SITE PLAN & ARCHITECTURAL
COMMISSION
AGENDA
MARCH 3, 2017

TO Site Plan and Architectural Commission *for March 3, 2017 hearing*

Consideration of plans for an approximately 20,000 square foot, three-story bank and office building on a one acre lot within the Regional Commercial zoning district and the Freeway Overlay District (C-R/F). Subject site is located at the southeast corner of Biddle Road and Progress Drive (Map lot 371W19BB 1504).

Revised Date: 2/6/2017
File Number: AC-16-153
Reference: PA-15-102

setbacks

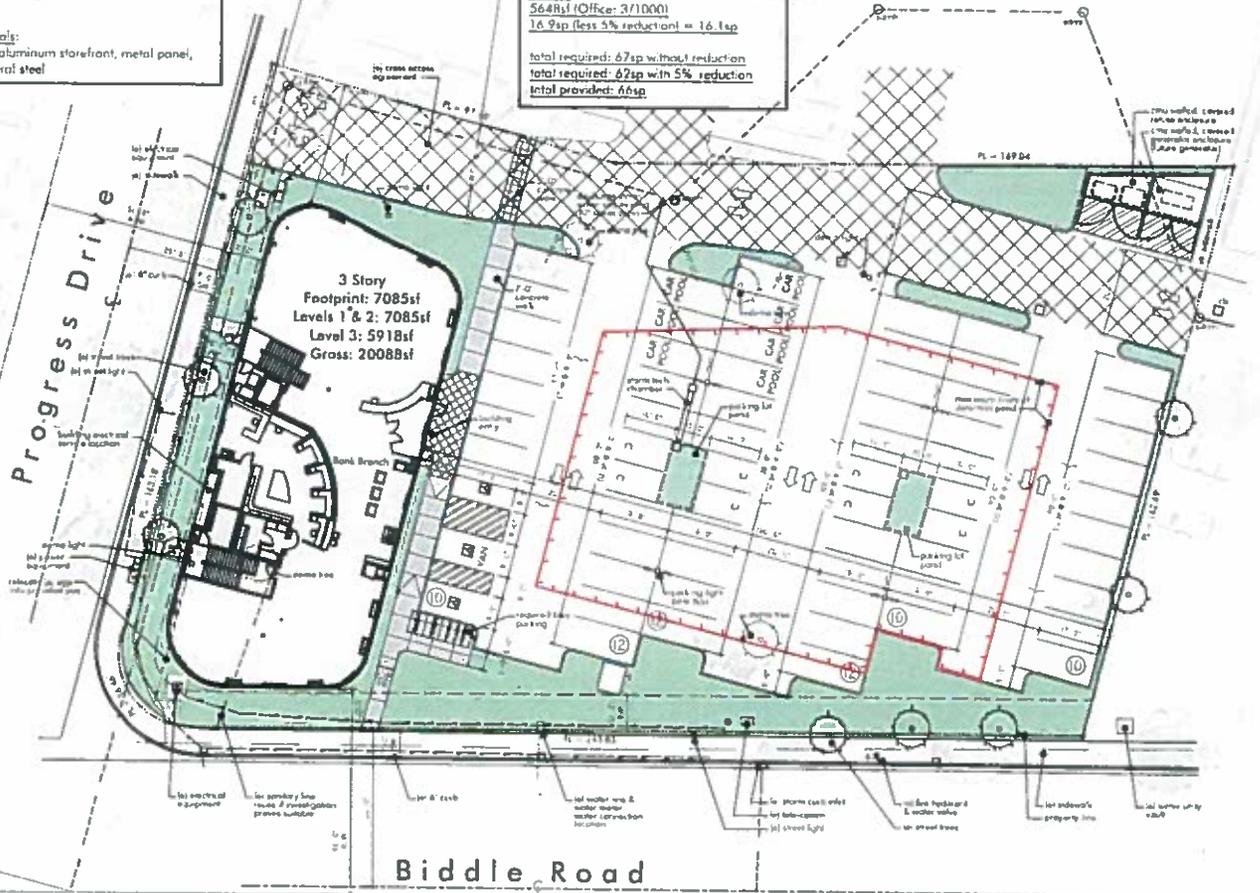
Front = dedication required = 10'-0" PUE
Side (street frontage) = dedication required = 10'-0" PUE
Side = n/a
Side = 14'-3"
Rear = 14'-3"
